Field Inspection Report

Riverside Apartments · Annual Structural Inspection

Projects	Riverside Apartments · Annual Structural Inspection
Client	Riverside Properties Ltd.
Ref. No.	INSP-2026-014
Address	1200 Riverside Blvd
Inspection date	Jul 27, 2026

Fig. 1

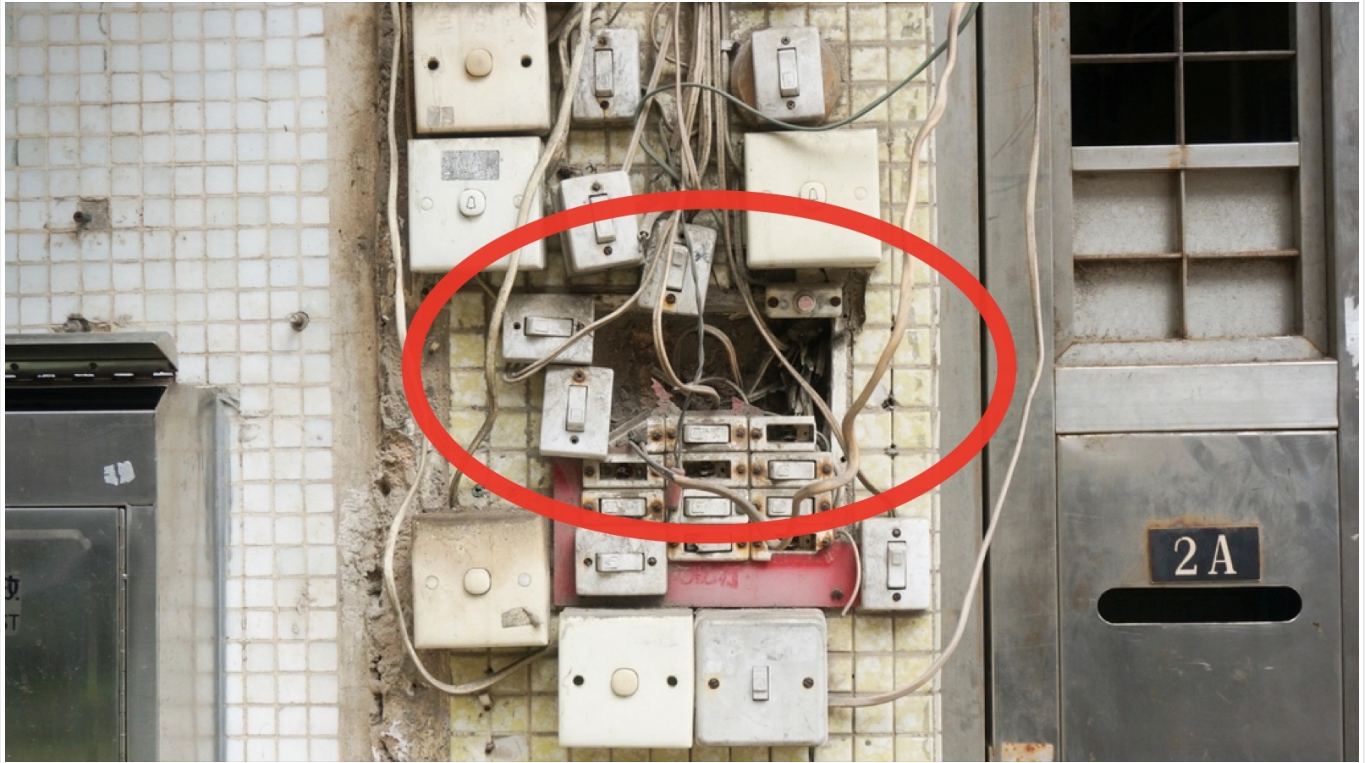
● In progress ● Urgent ● Corridor · electrical cabinet · Li Wentao 2026/7/27, 18:37

Several conductors are exposed at the corridor junction box and the cover plate is missing, an electric-shock hazard. Circuit isolated; a licensed electrician will reinstate the cover and terminate the conductors.

Fig. 1

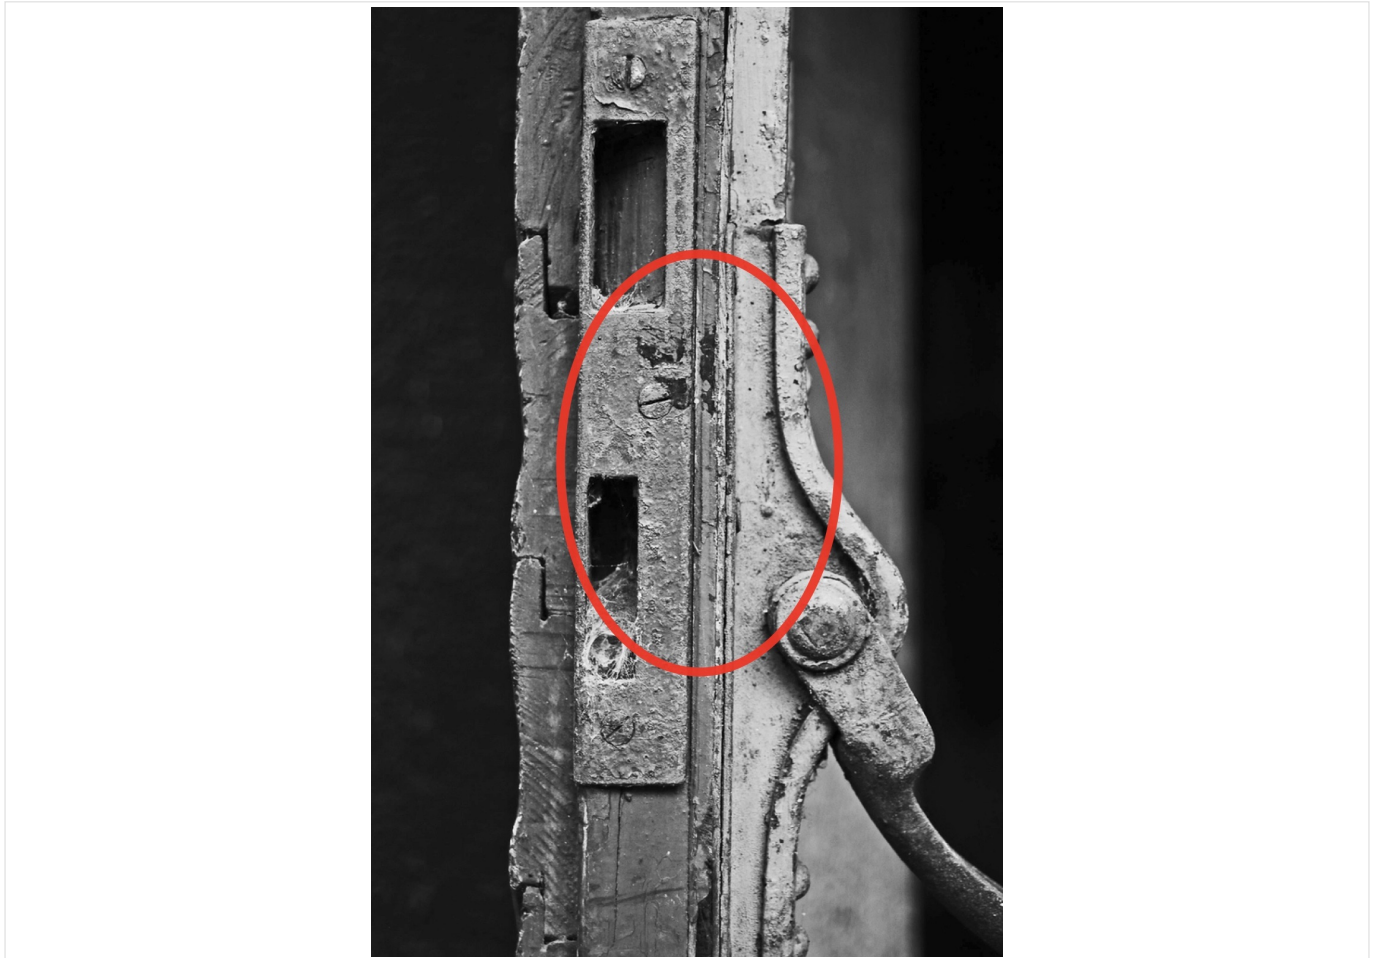
● In progress ● High ● Main entrance · Unit 4 · Li Wentao 2026/7/27, 18:37

The entrance latch mechanism is corroded and does not fully latch, affecting security. Replacement with a stainless mortice lock is scheduled; interim patrol notified.
